Access Compliance Report Public Rights-of-Way (Curb Ramps)

Intersection ID: 12878 Main Street: W_MOREHEAD_ST Cross Street: WINNIFRED_ST Location: SW

ADA ID: 5DDAA9AF69BA Ramp Type: PerpDiag Initial Pass/Fail: Fail Overall Compliance: No Severity Score: 21.25

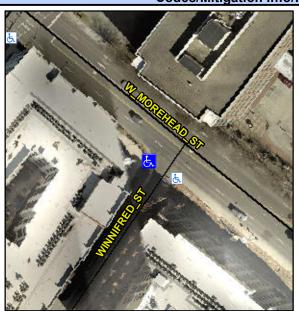
PROW/ADA:
Not Found, R304.5.1, R304.2.2

Remove & Replace Curb Ramp With
Two New Directional Ramps or
Equivalent.
